Well Name: JICARILLA APACHE F	Well Location: T25N / R5W / SEC 16 / NWNW / 36.404005 / -107.370124	County or Parish/State: RIO ARRIBA / NM
Well Number: 8	Type of Well: CONVENTIONAL GAS WELL	Allottee or Tribe Name: JICARILLA APACHE
Lease Number: JIC149	Unit or CA Name:	Unit or CA Number:
US Well Number: 3003982338	Well Status: Producing Gas Well	Operator: DJR OPERATING LLC

Notice of Intent

Type of Submission: Notice of Intent	Type of Action: Plug and Abandonment
Date Sundry Submitted: 06/29/2022	Time Sundry Submitted: 11:45
Date proposed operation will begin: 06/29/2022

**Plug and Abandonment Procedure**  
**for**  
**DJR Operating, LLC**  
**Jicarilla Apache F 8**  
**API # 30-039-82338**  
**NW/NW, Unit D, Sec. 16, T25N, R5W**  
**Rio Arriba County, NM**

**DJR Operating, LLC**  
**Proposed Wellbore Diagram**  
**Jicarilla Apache F 8**  
**API # 30-039-82338**  
**NW/NW, Unit D, Sec 16, T25N, R5W**  
**Rio Arriba County, NM**

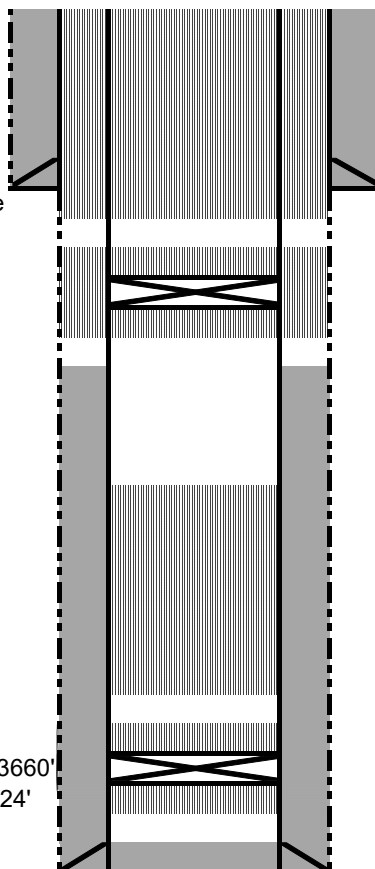
You are also required to place cement excesses per 4.2 and 4.4 of the attached General Requirements.
